Site Accessibility Evaluation

**Taco Bell Store #024598
(Pre)**

**7246 Central Ave
Toledo, OH 43617**

Pre Inspection

Finding: 4

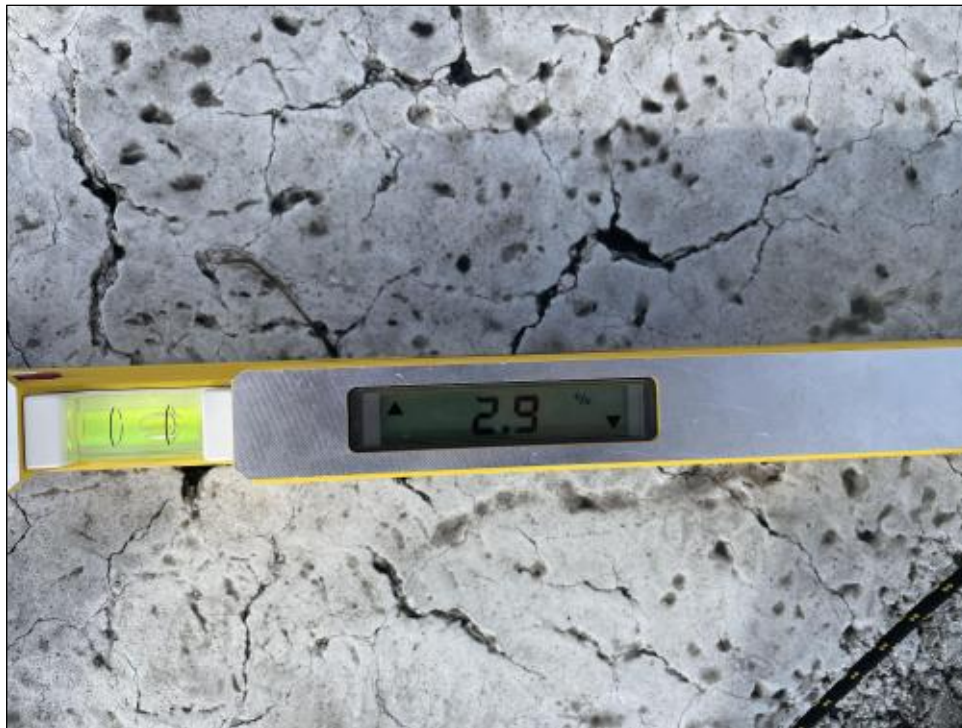
The accessible path of travel between the building and the public way on the site has cross slopes greater than 2%.

Surface cross slopes shall not exceed one unit vertical in 48 units horizontal (2-percent slope).

2.9%-4.1%

Finding: 31

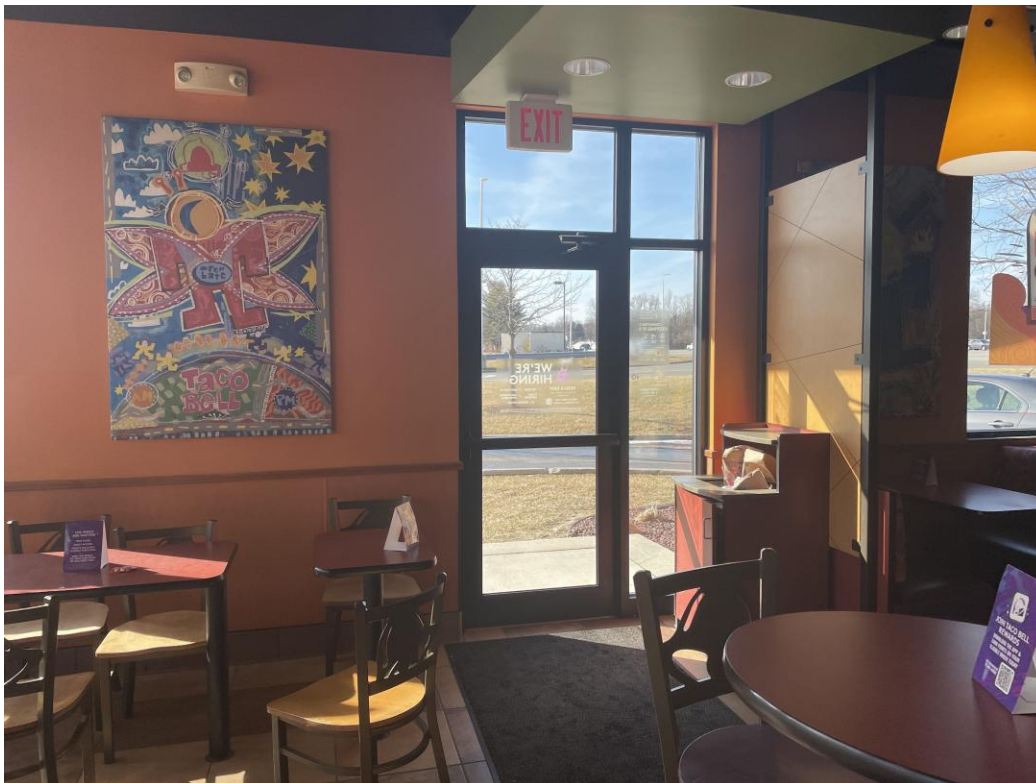
The tactile EXIT sign is missing at the door.

Wall signs identifying exits shall have characters raised 1/32 inch minimum and shall be uppercase characters a minimum of 5/8 inch and a maximum of 2 inches high. Braille shall be placed directly below the tactile characters; flush left or centered. Signs shall be located a minimum of 48 inches above the floor, measured from the baseline of the lowest tactile characters and 60 inches maximum above the finish floor or ground surface, measured from the baseline of the highest tactile characters.

Where a tactile sign is provided at a door, the sign shall be located on the latch side. Where a tactile sign is provided at double doors the sign shall be located to the right of the right-hand door. Where there is no wall space at the latch side of a single door or at the right side of double doors, signs shall be located on the nearest adjacent wall.

Missing

Finding: 42

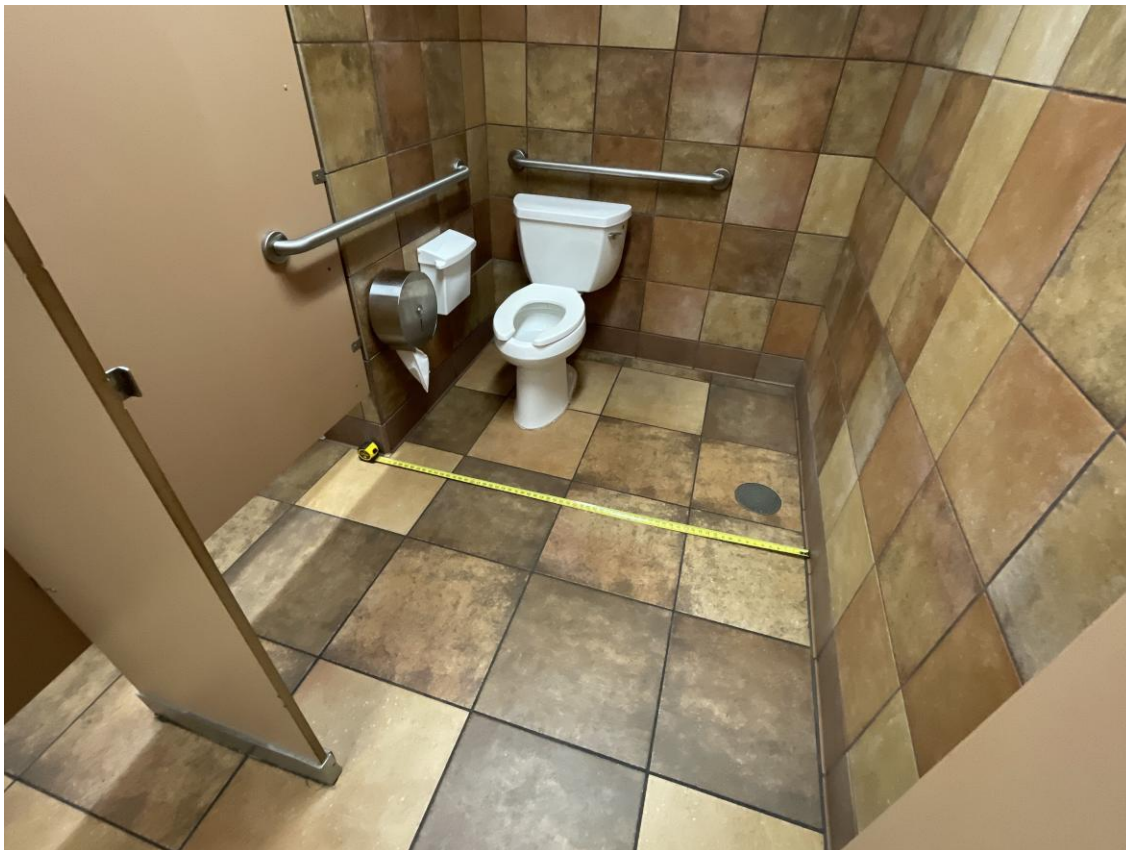
The accessible toilet compartment does not provide proper toe clearance on the front and/or side partition.

The front partition and at least one side partition shall provide a toe clearance of 9 inches minimum above the finish floor and 6 inches deep minimum beyond the compartment-side face of the partition, exclusive of partition support members.

Toe clearance at the front partition is not required in a compartment greater than 62 inches deep with a wall-hung water closet or 65 inches deep with a floor-mounted water closet. Toe clearance at the side partition is not required in a compartment greater than 66 inches wide.

Partial/ (63" wide stall)

NOTE: IF THIS COMPARTMENT WAS ORIGINALLY CONSTRUCTED PRIOR TO MARCH 2010, THEN IT CAN REMAIN AS-IS. OTHERWISE, IT MUST BE MODIFIED TO CONFORM TO CURRENT ADA STANDARDS.
